Notes from E&S Inspection on 6/11/2025

Site inspection photos taken during inspection on 6/11/2025

This is an aerial image to depict areas that need additional erosion and sediment controls.

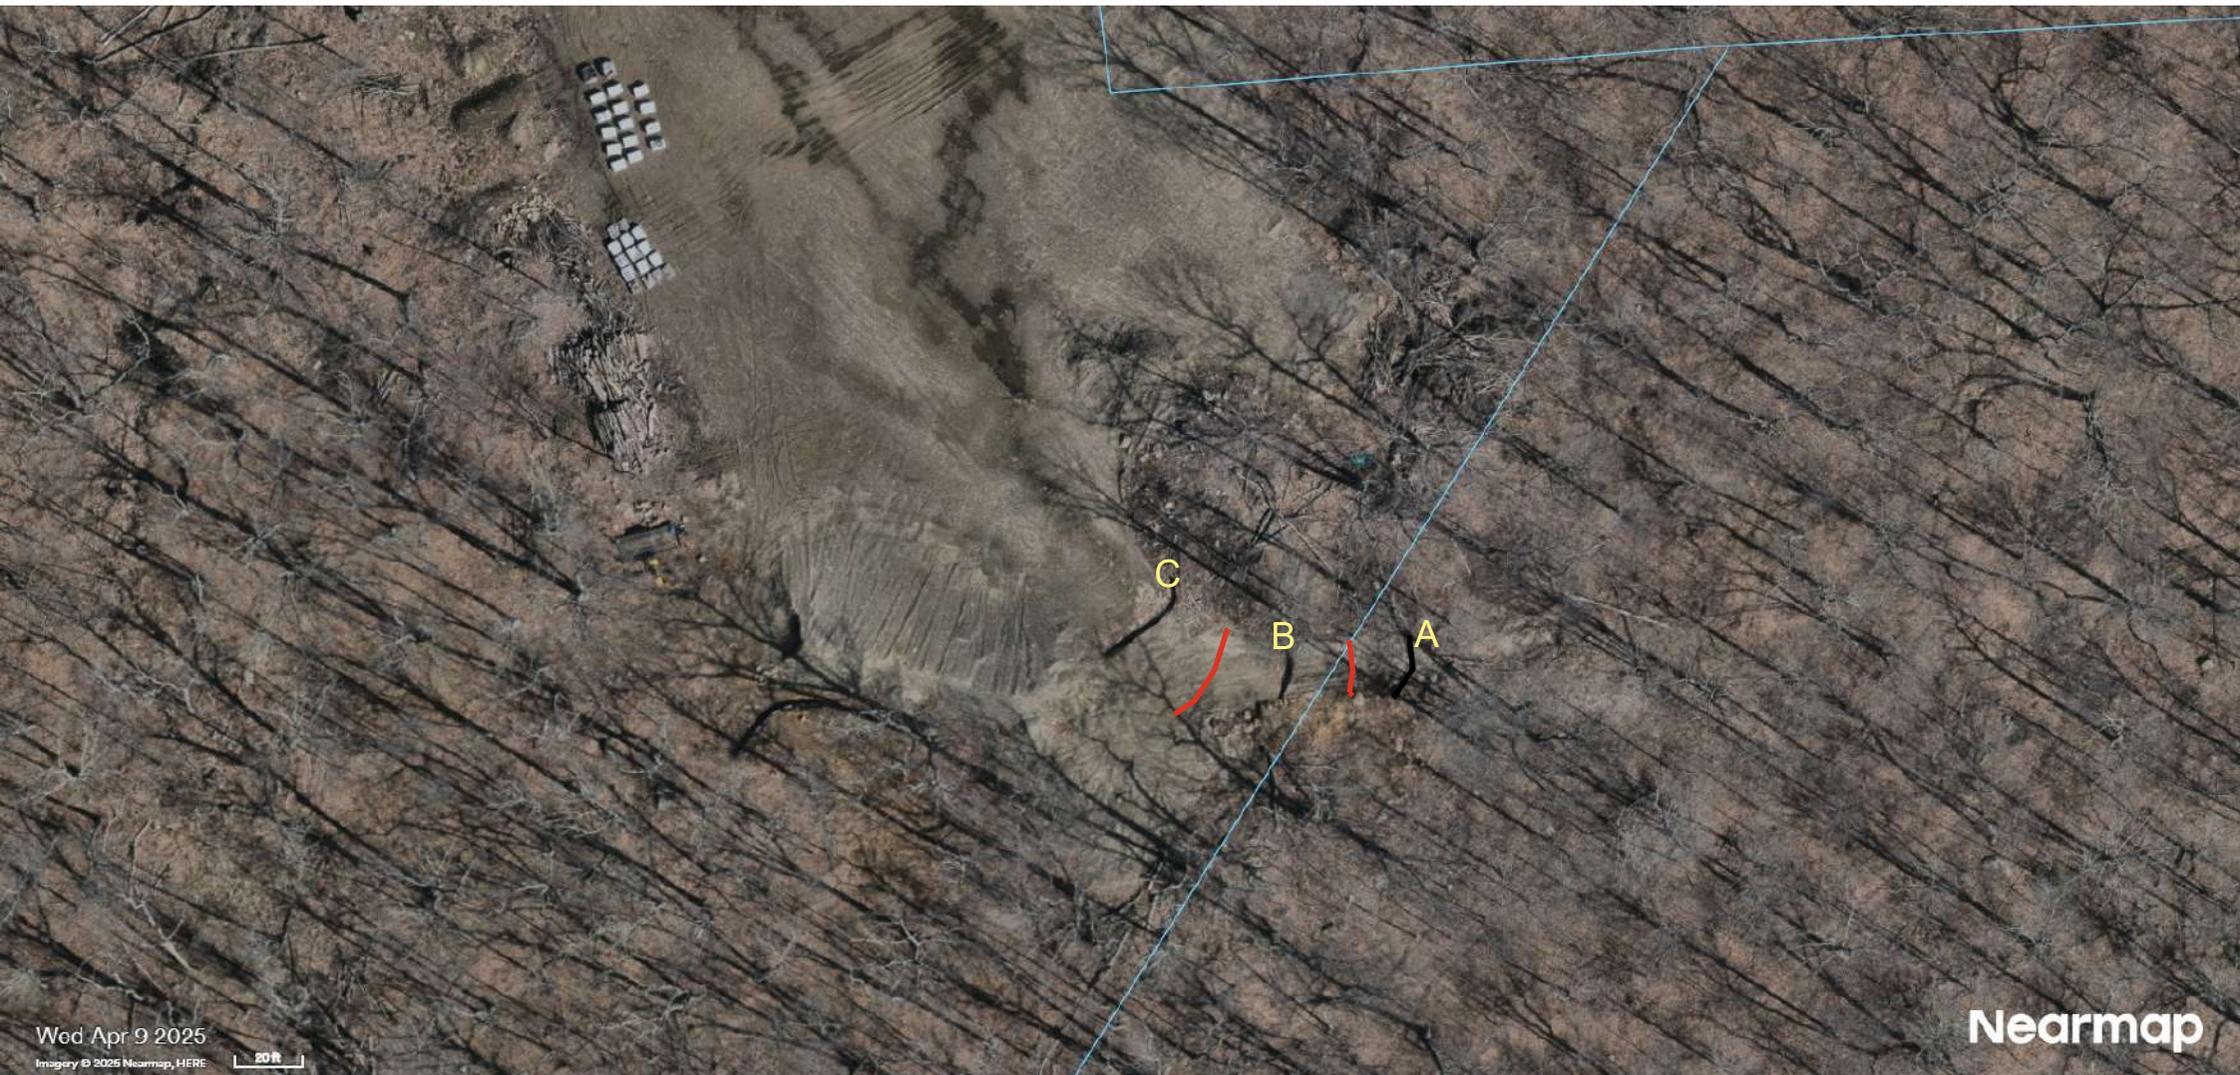
The red lines are situated between existing rows of silt fencing and represent the approx location you need to install rows of staked-in hay bales.

The row of silt fence labeled A, needs to be maintained and repaired. There is too much sediment build up and it is bypassing the silt fence.
